## Work Order ID 115639

<b>DART AEROSPACE LTD</b>		<b>Work Order:</b>	115639
<b>Description: Bar</b>		<b>Part Number:</b>	D3196-4
<b>Inspection Dwg: D3196 Rev: C</b>		<b>Page 1 of 1</b>

**D3196-1 BAR**

DRAWING NO. D3196	TITLE BAR	REV. C	DART AEROSPACE LTD ENGINEERING ORDER		D.E.O. NO. D3196-C-1	SHEET NO. SHEET 1 OF 2	SCALE NTS
DRAWN <i>ASS</i>	CHECKED <i>[Signature]</i>	MFG. APPR. <i>[Signature]</i>	APPROVED <i>[Signature]</i>		DE APPR. <i>[Signature]</i>		
DATE 08.08.27	DATE 08.08.28	DATE 08.08.29	DATE 08.08.29	DATE 08.08.29	DATE 08.09.04

D3196-1 BAR

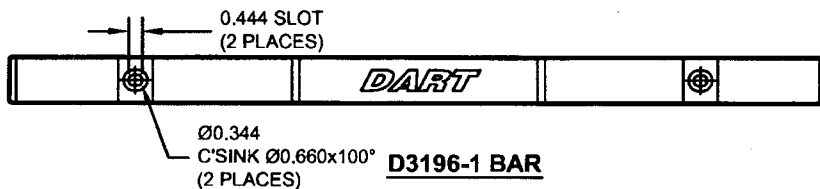
SHEET 1 MODIFY SLOT DIMENSIONING ON D3196-1 AS SHOWN:

D3196-3 BAR

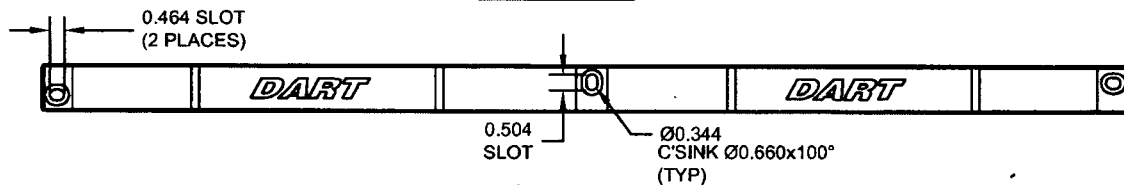
SHEET 2 MODIFY SLOT DIMENSIONING ON D3196-3 AS SHOWN:

D3196-4 BAR

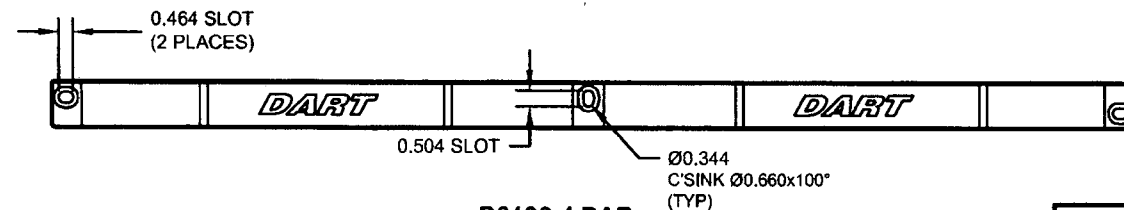
SHEET 3 MODIFY SLOT DIMENSIONING ON D3196-4 AS SHOWN:

DRAWING NO. D3196	TITLE BAR	REV. C	DART AEROSPACE LTD ENGINEERING ORDER		D.E.O. NO. D3196-C-1	SHEET NO. SHEET 2 OF 2	SCALE NTS
DRAWN ASS	CHECKED	MFG. APPR.	APPROVED		DE APPR.		
DATE 08.08.27	DATE 08.08.28	DATE 08.08.29	DATE 08.08.29	DATE 08.08.29	DATE 08.09.04

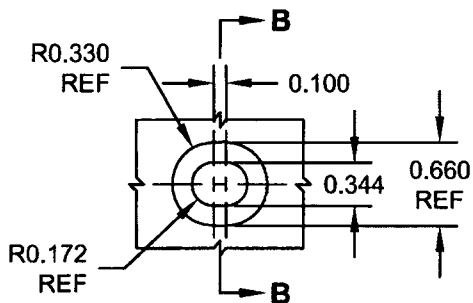
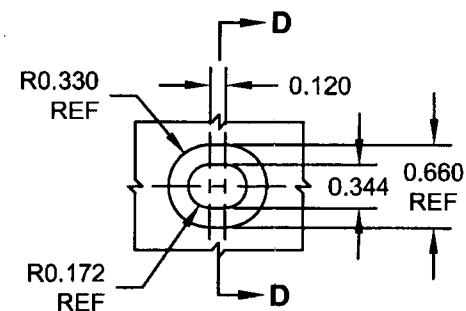
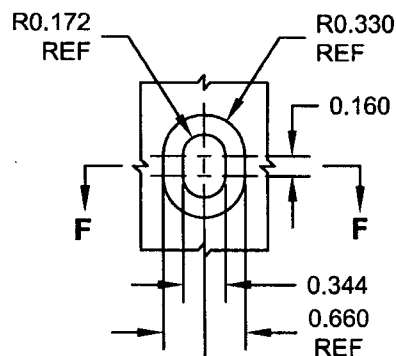
NOTE: THIS CHANGE HAS BEEN DONE TO CLARIFY SLOT DIMENSIONS ONLY. NO CHANGES HAVE BEEN MADE TO THE PARTS  
SEE NCR 08-051 FOR FURTHER INFORMATION  
ALL OTHER INFORMATION REMAINS UNCHANGED
